STANDARD DEPARTURE CHART-INSTRUMENT

RJFN / NYUTABARU

NIPPO SEVEN DEPARTURE

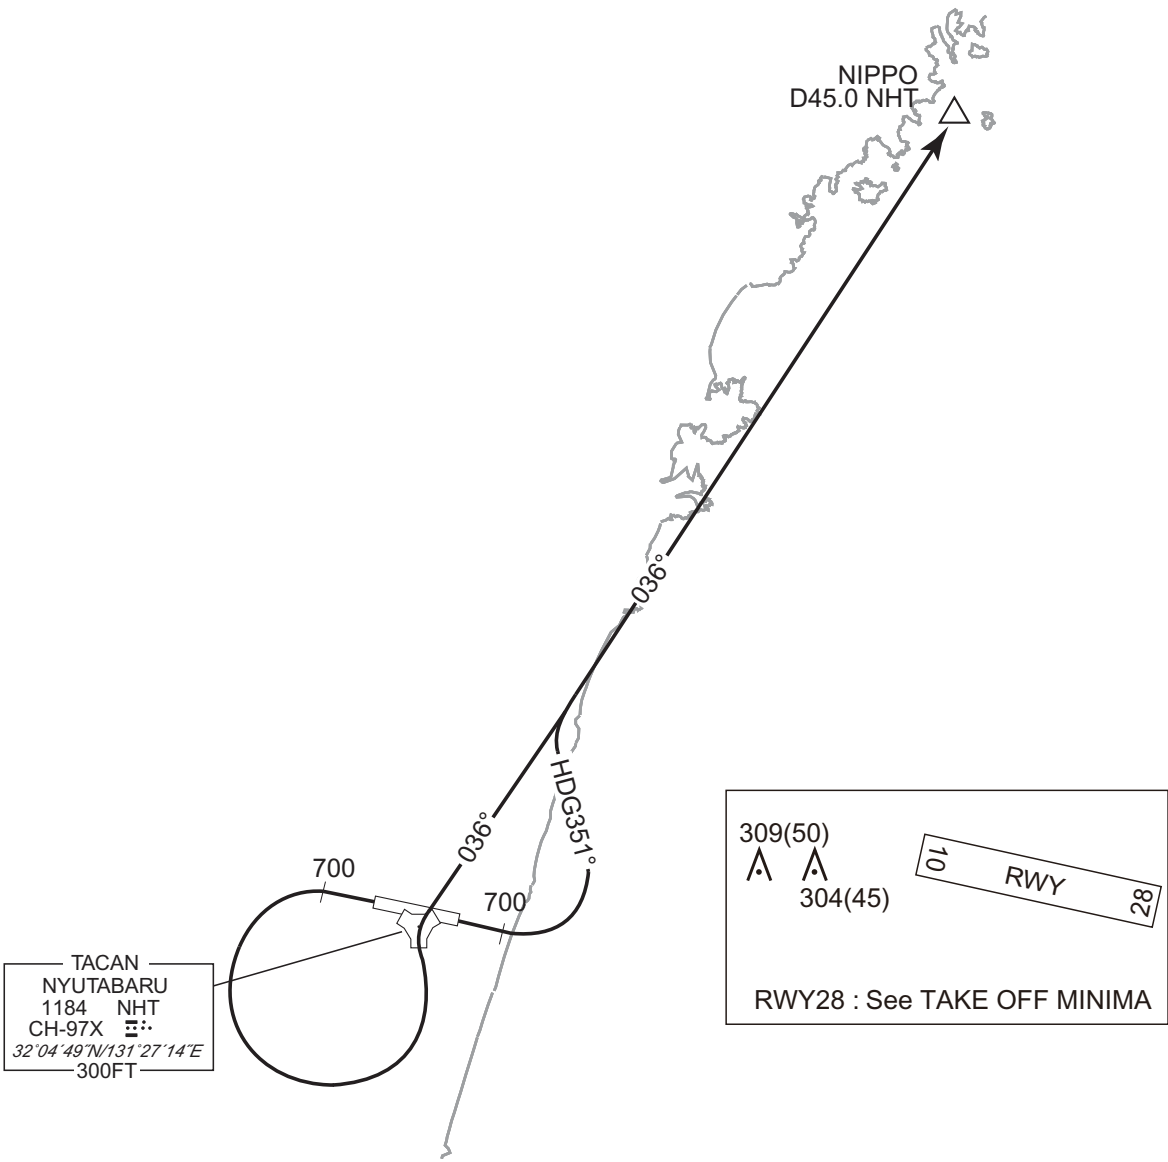
CHANGE : PROC renamed(NIPPO SEVEN DEPARTURE). PROC course(NIPPO SEVEN DEPARTURE). YATOJI TWO DEPARTURE abolished.
Restriction. Note, OBST added.

SAITO ONE DEPARTURE

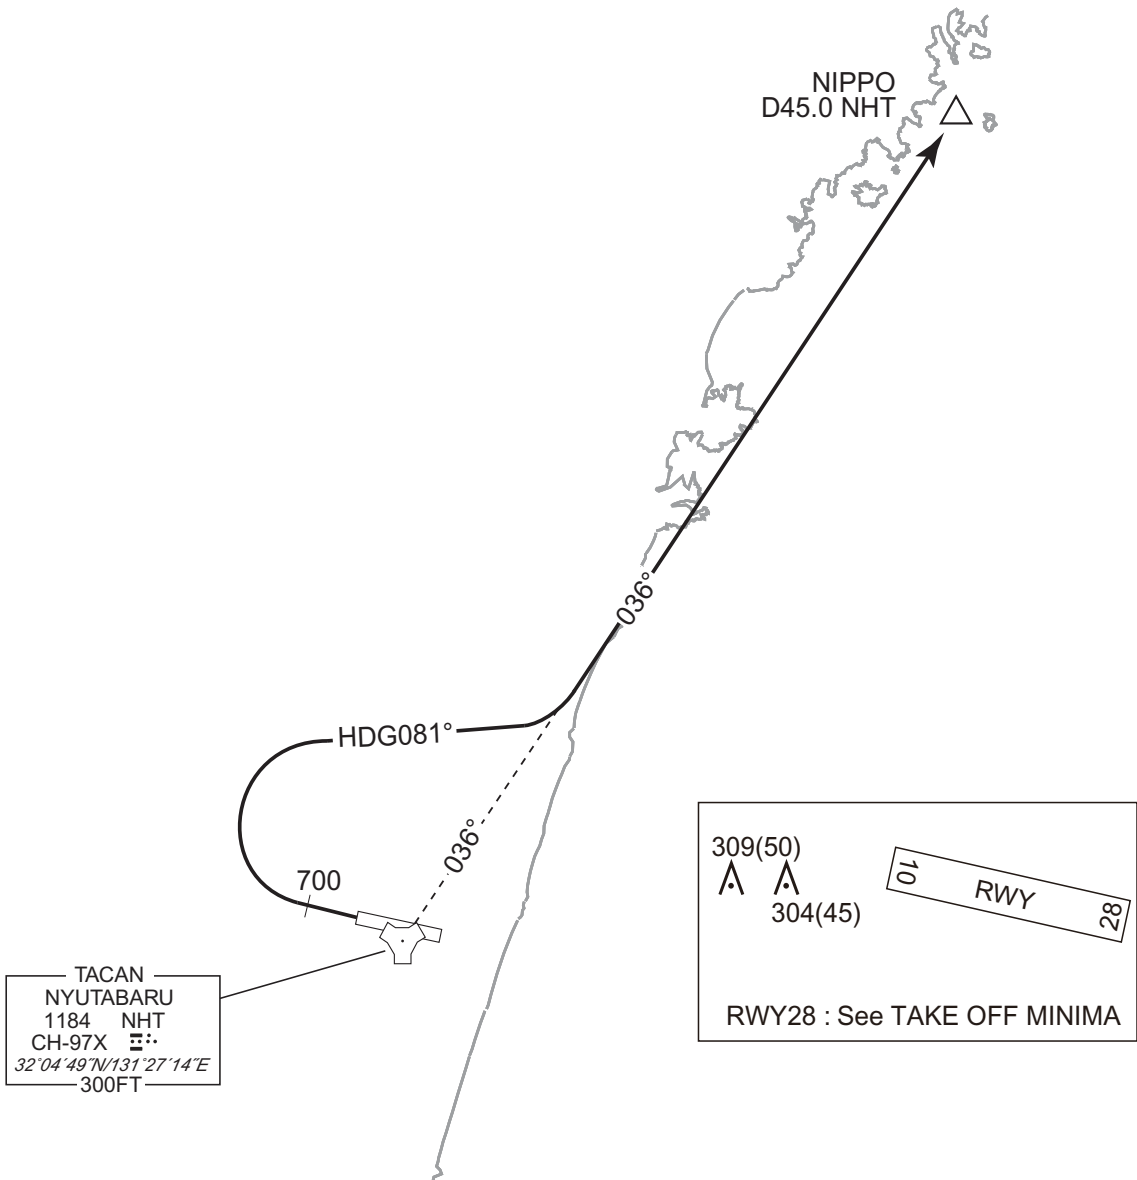
CHANGE : New PROC.

TENSO ARRIVAL

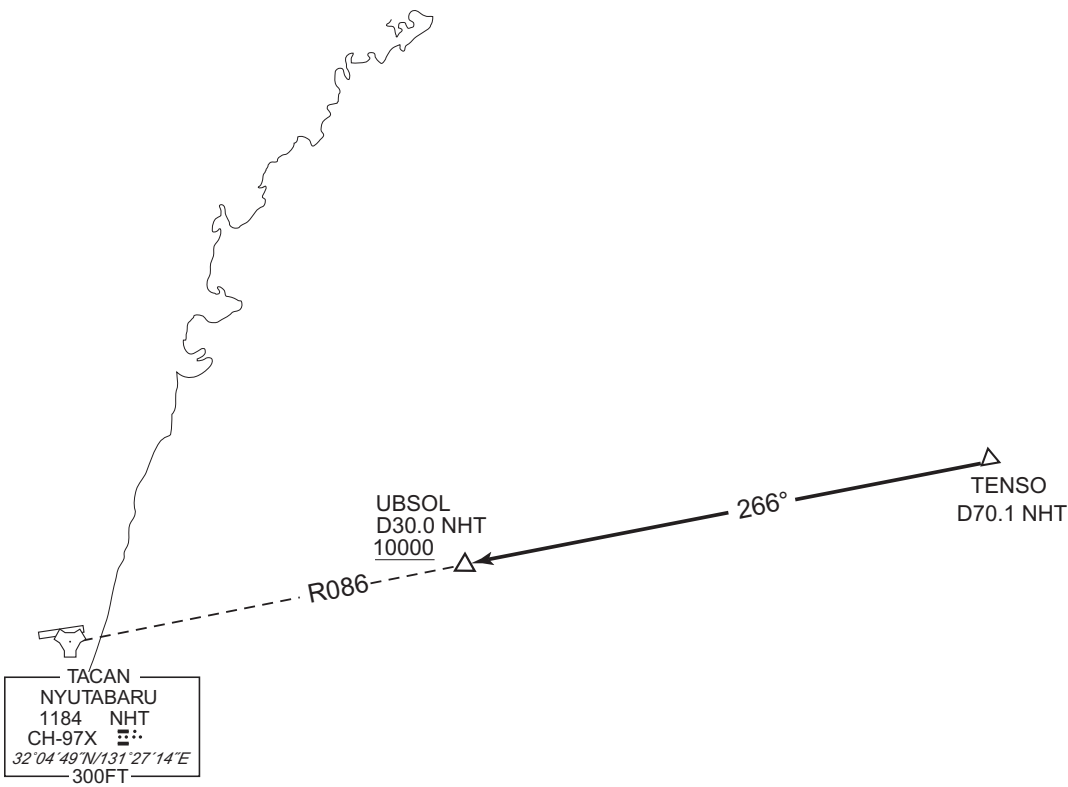
CHANGE : PROC course. UBSOL established. ALT restriction.

TACAN Z RWY28

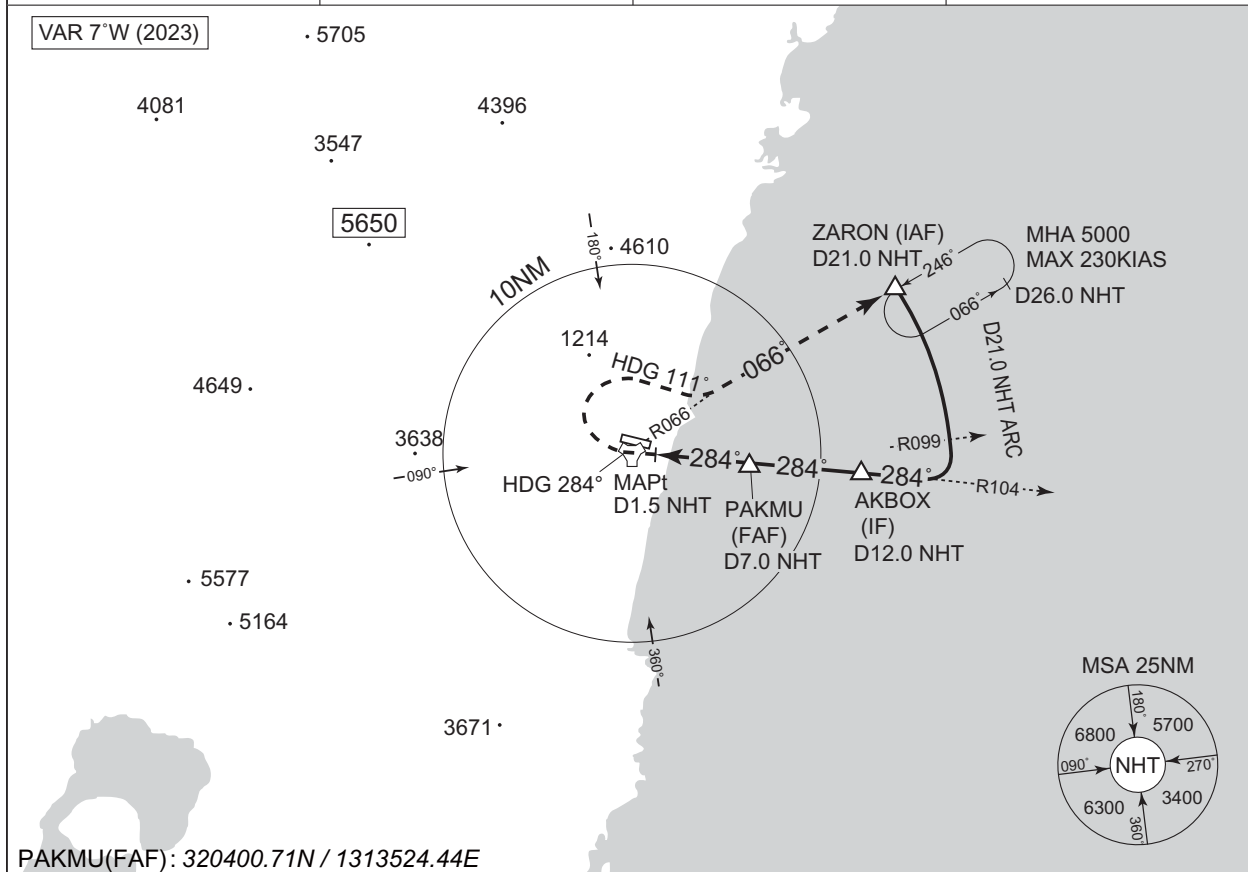
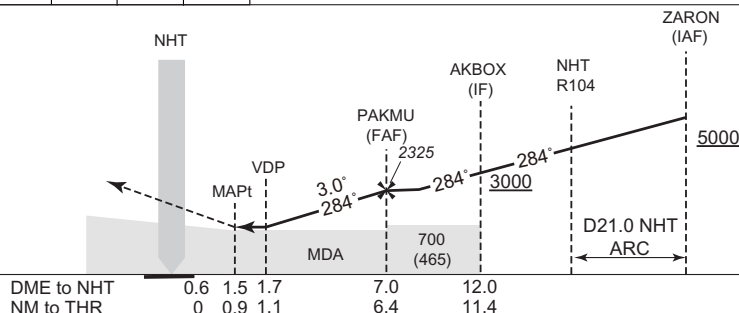
CHANGE : PROC course. Missed APCH course. MINIMA. PAKMU,AKBOX established. NM to THR.ALT(3.0°APCH Path), DME to NHT added.
Missed APCH climb gradient MNM added. VAR.

RJFN / NYUTABARU

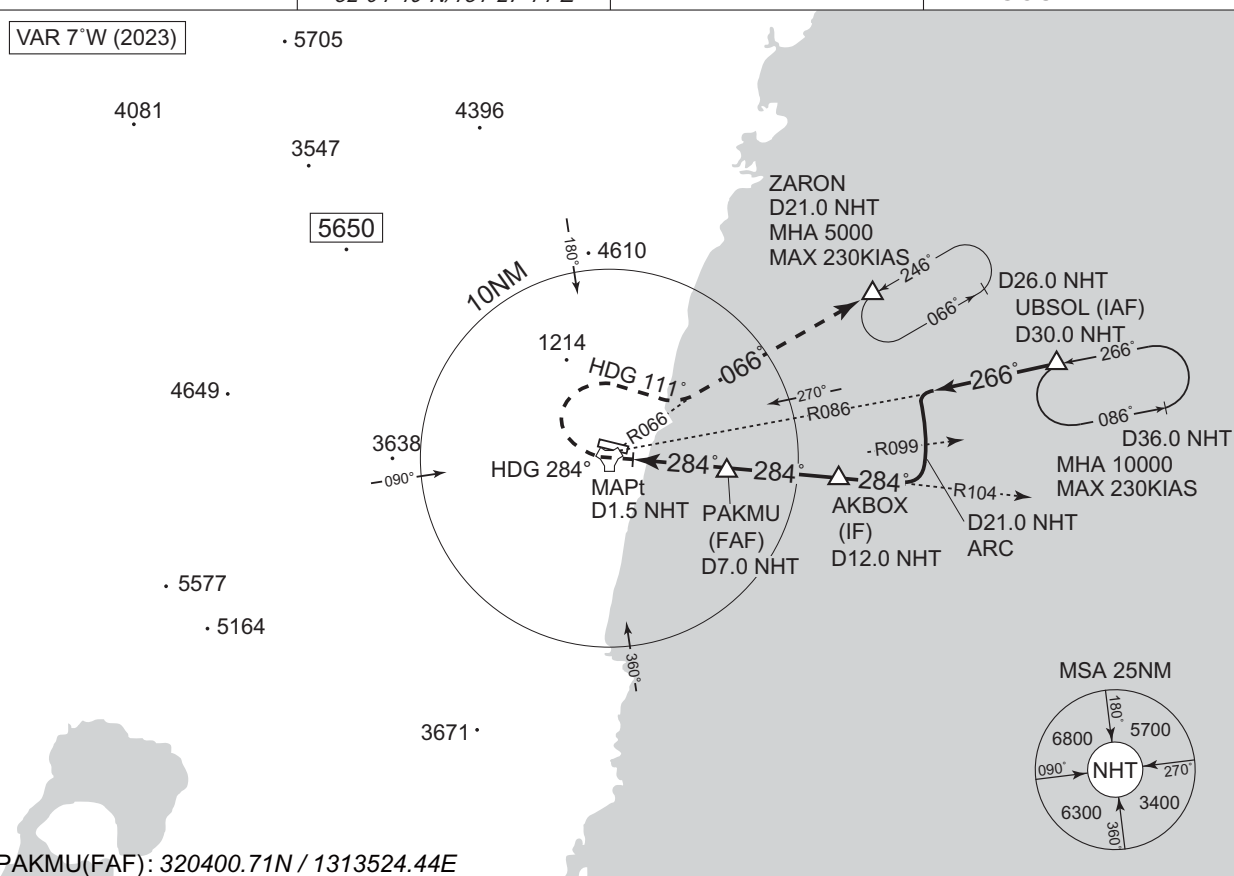
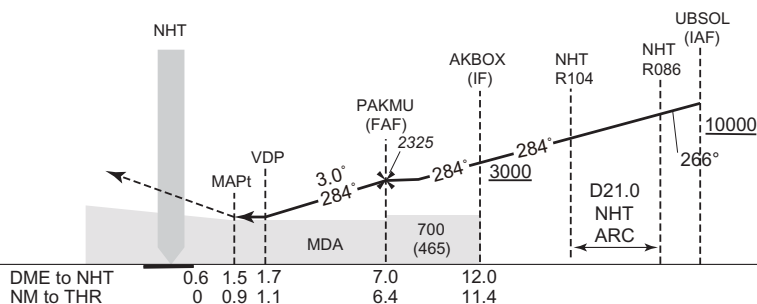
CHANGE : PROC course. Missed APCH course. MINIMA. UBSOL, PAKMU, AKBOX established. NM to THR. ALT(3.0°APCH Path), DME to NHT added.
Missed APCH climb gradient MNM added. VAR.
